MITIGATION PLAN

Final Report for IRT

HUNTSMAN MITIGATION SITE

Subject: Mitigation Plan Report and Construction Plans
Huntsman Mitigation Site, Wilkes County
Yadkin River Basin – CU# 03040102
DMS Project ID #100123
USACE #SAW-2019-00836

2.3.1

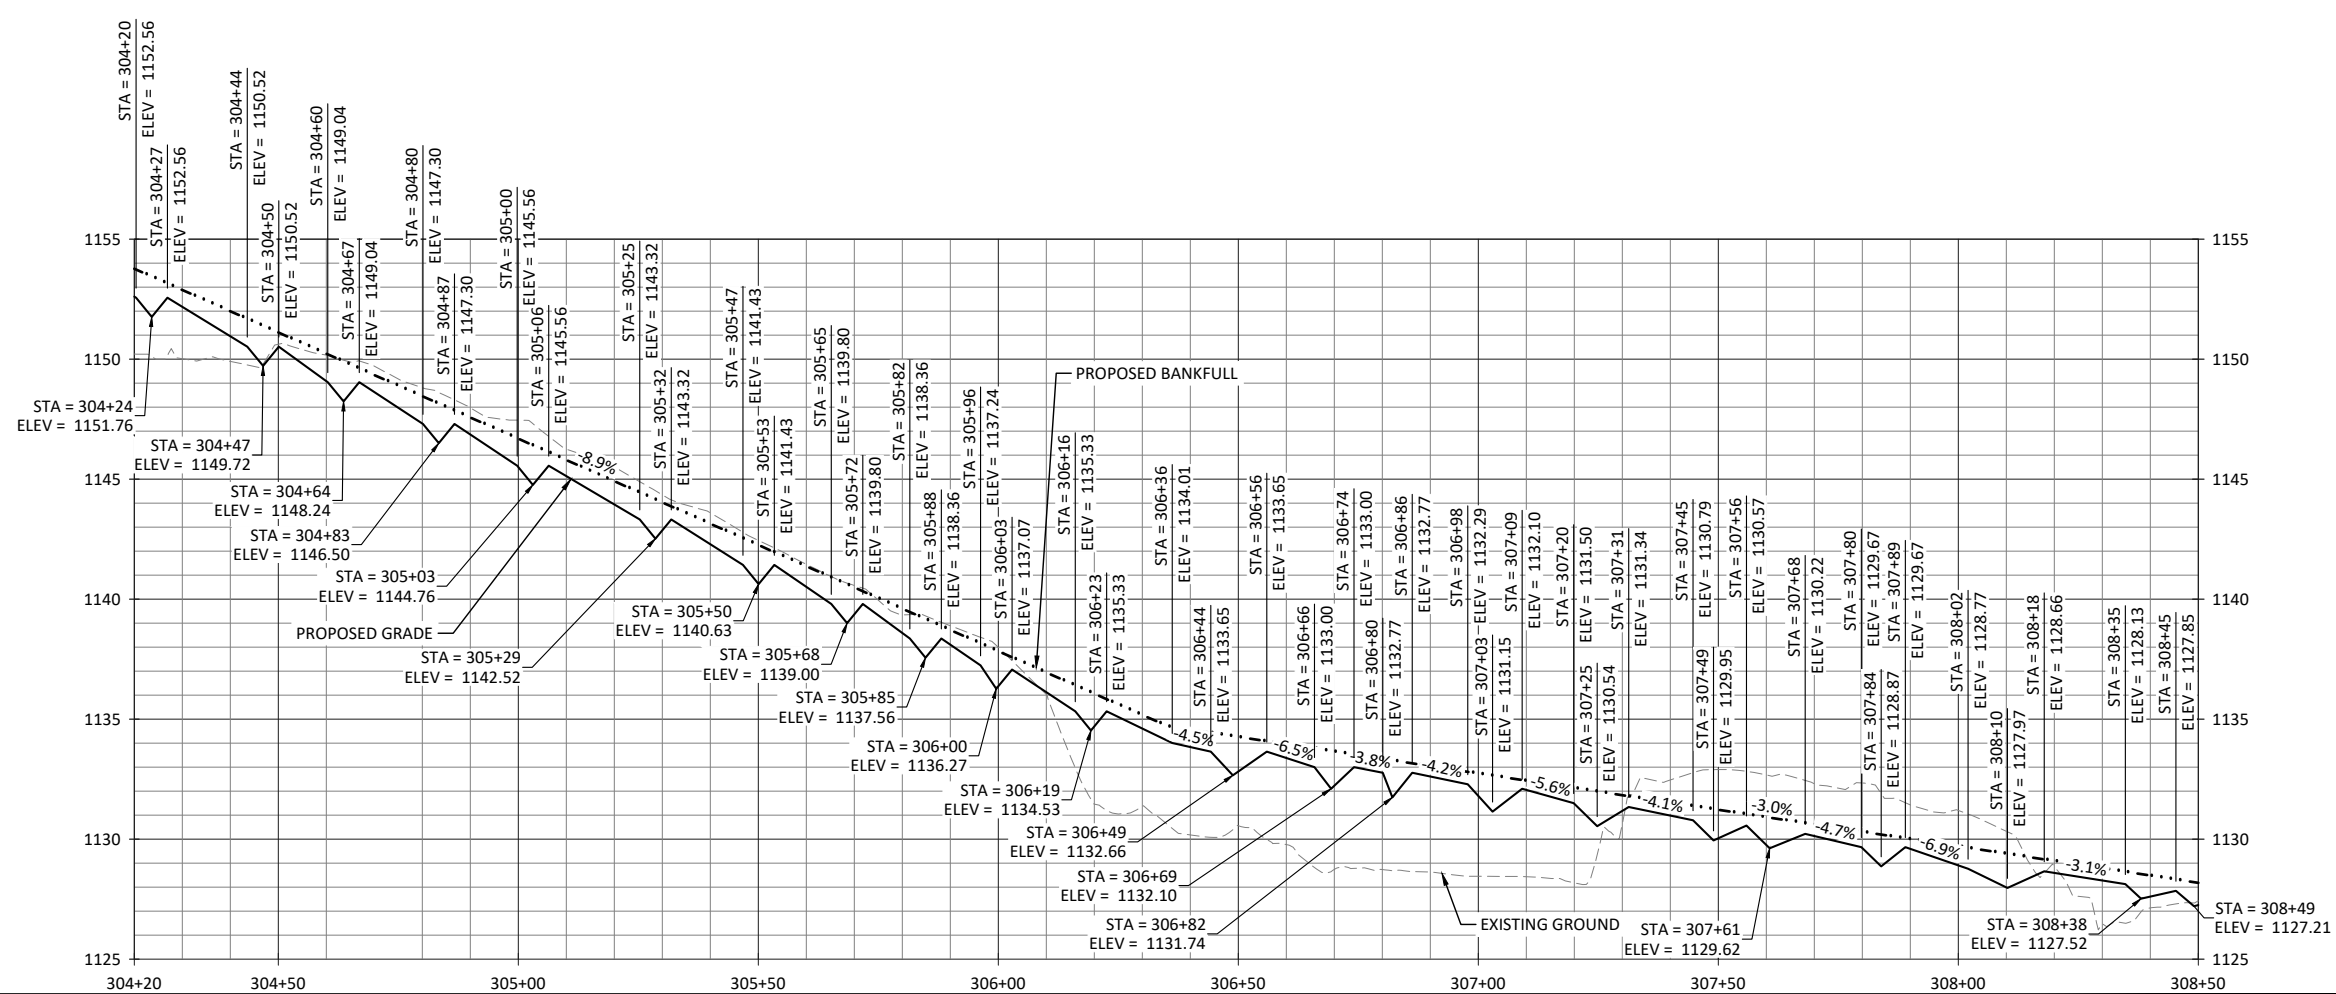
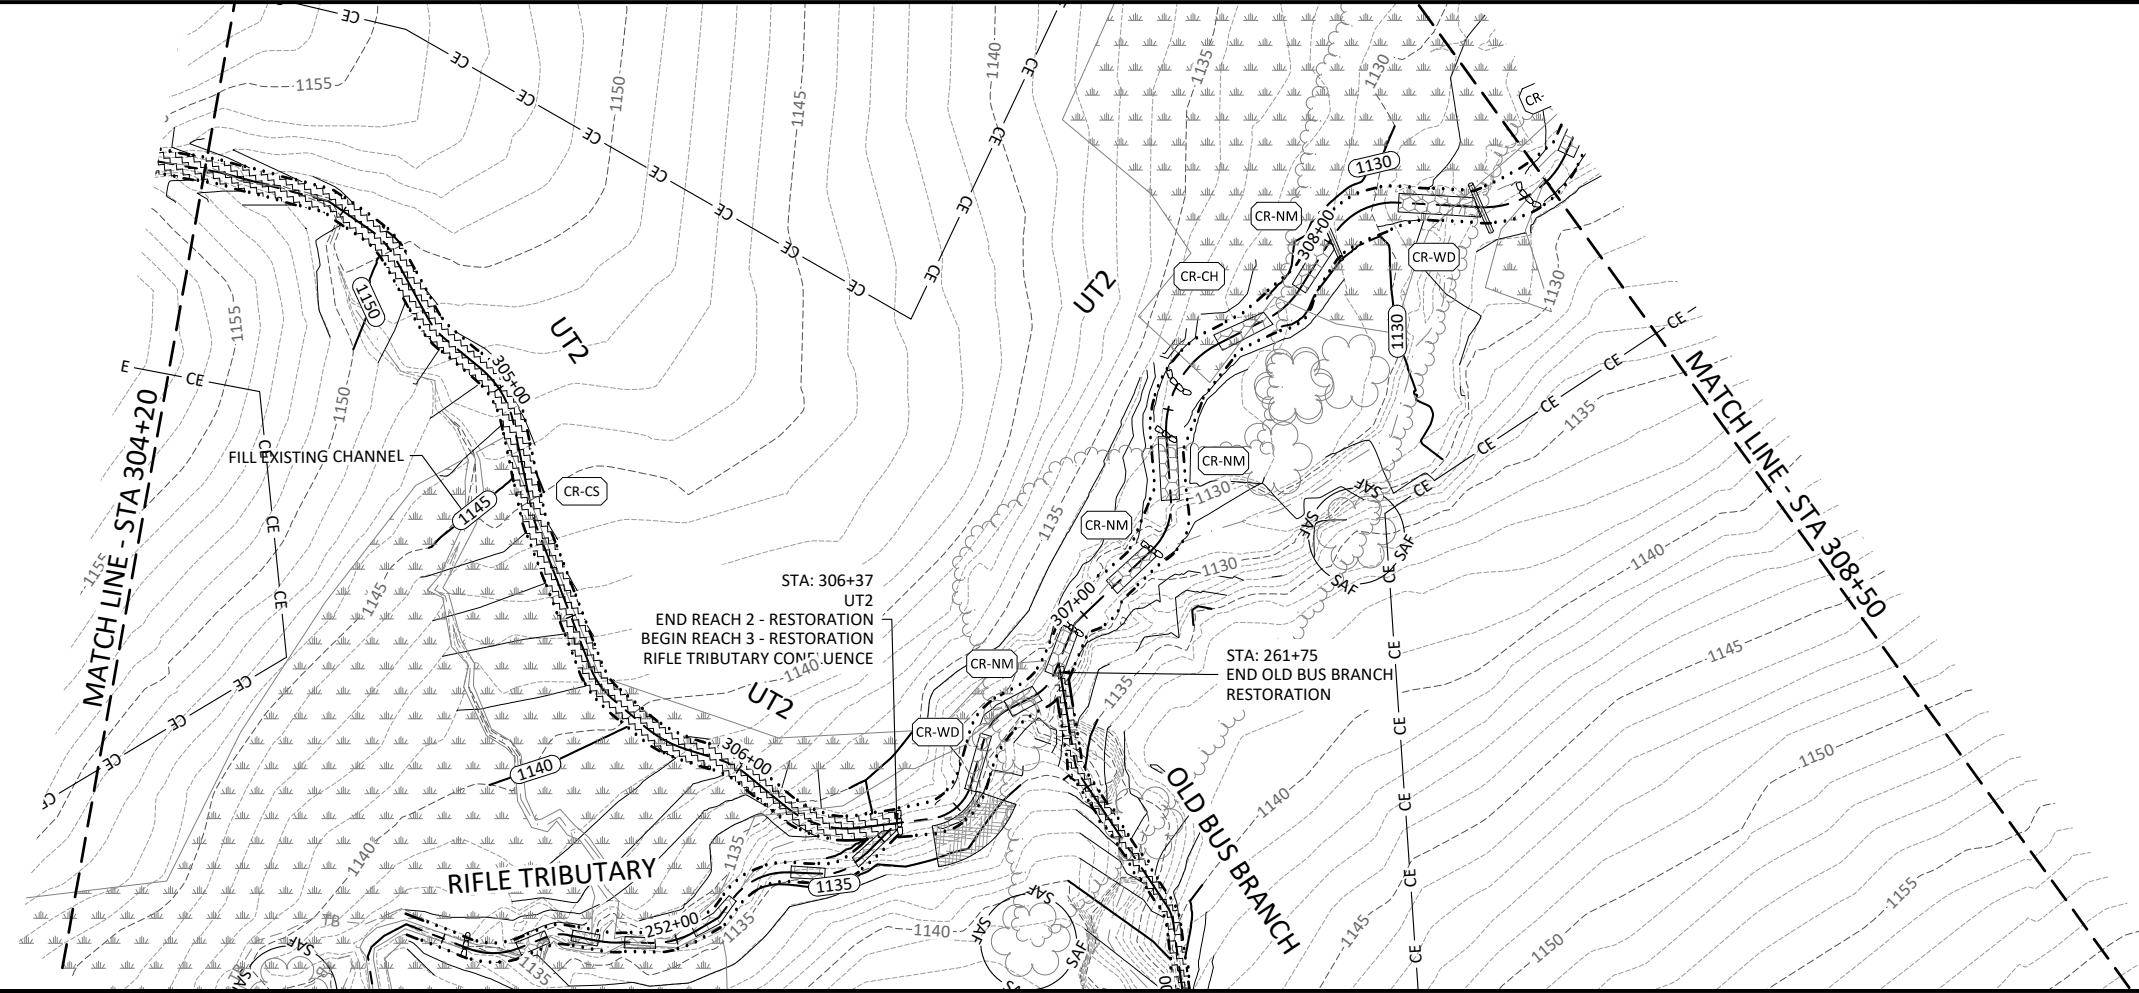
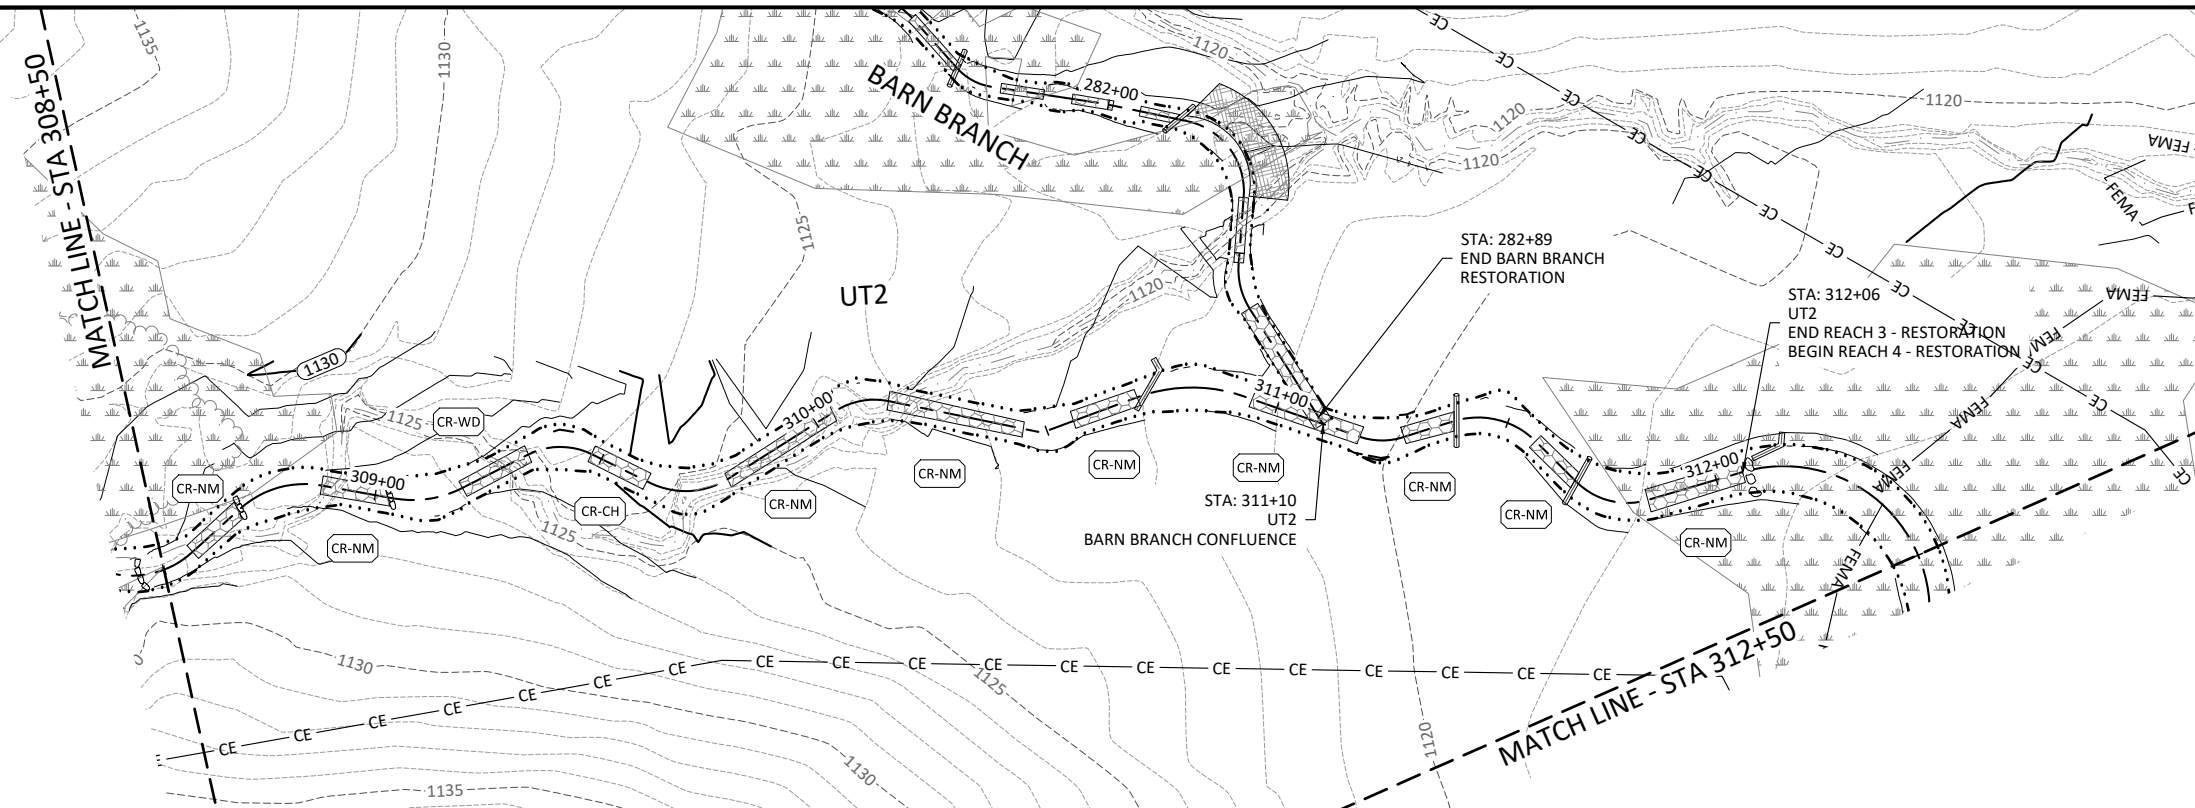
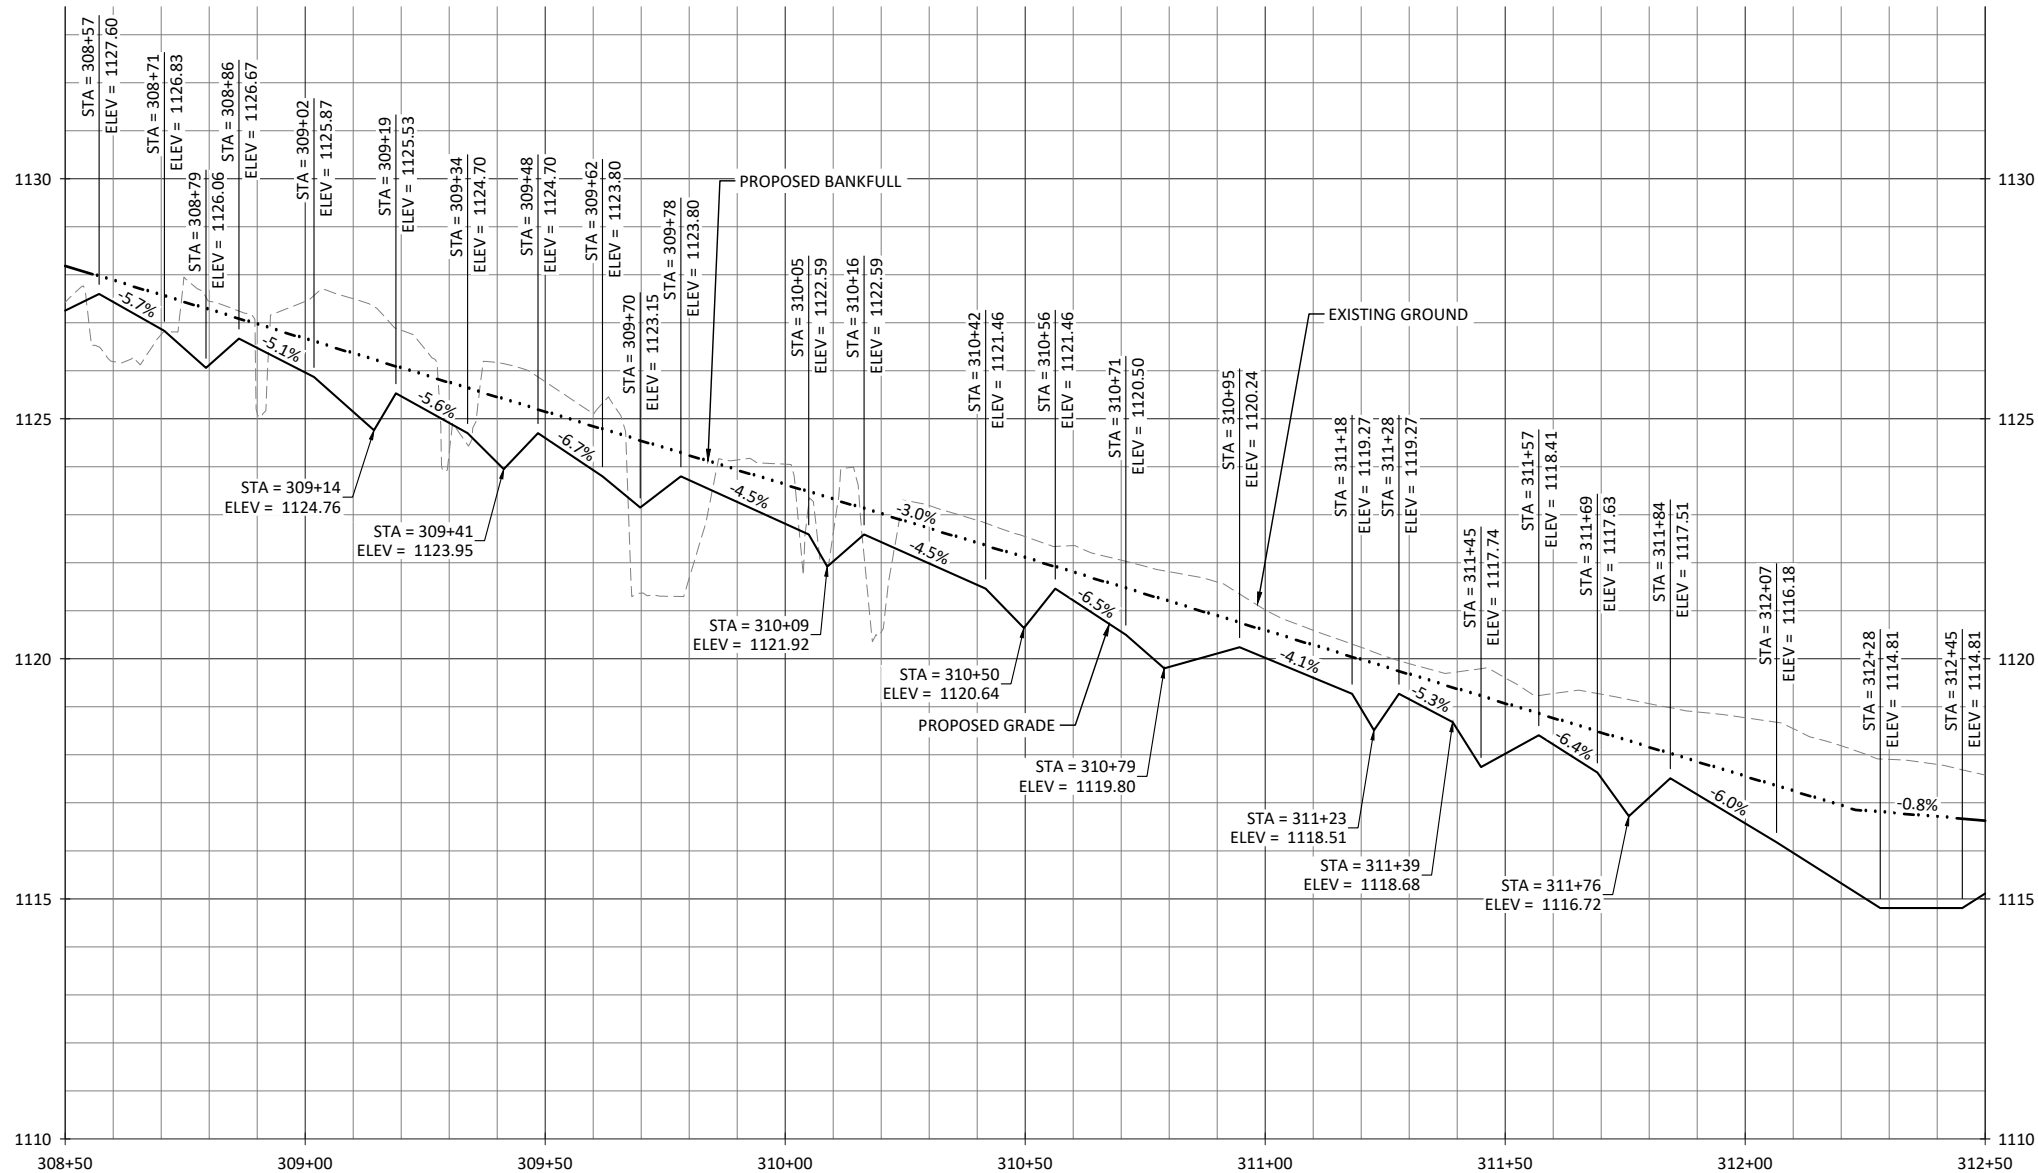
- a) Wildlands acknowledges your above considerations. Please see the response to EPA Comment 1 for additional discussion on buffer width.**
- 18) The inclusion of LiDAR imagery would have been particularly useful especially with regard to UT2 and its proposed restored location.

- a) The topographic map has been updated with LiDAR contours. Please refer to Plan Sheets 2.3.1 – 2.3.4 for detailed topography along UT2.**
